# **Palo Verde Nuclear Generating Station Seismic Hazard Re-evaluation**

NRC Public Meeting  
Rockville, Maryland  
June 9, 2015

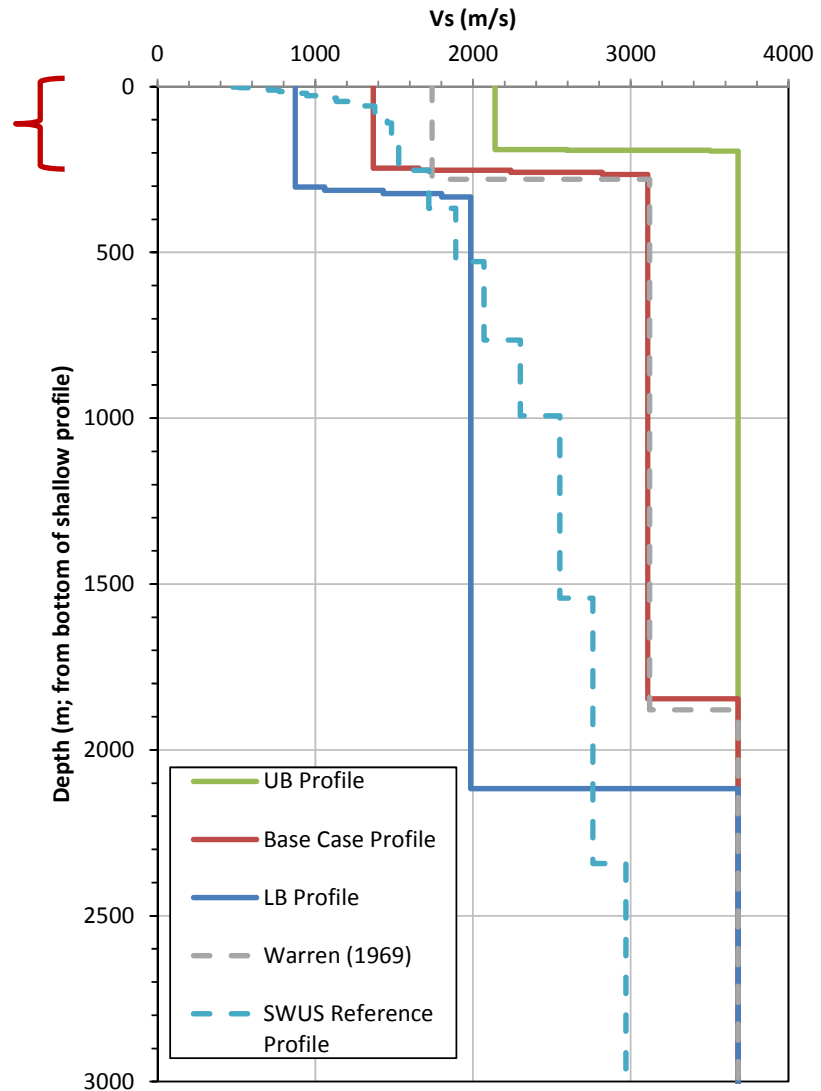
- b. the target deep  $V_s$  profile (including the use of a logarithmic standard deviation of 0.35 to develop the upper and lower profiles)*

- Vs from suspension-log data (LCI-B-2 profile)
- Thickness (& uncertainty) from UFSAR boreholes (consistent with Warren, 1969\*)
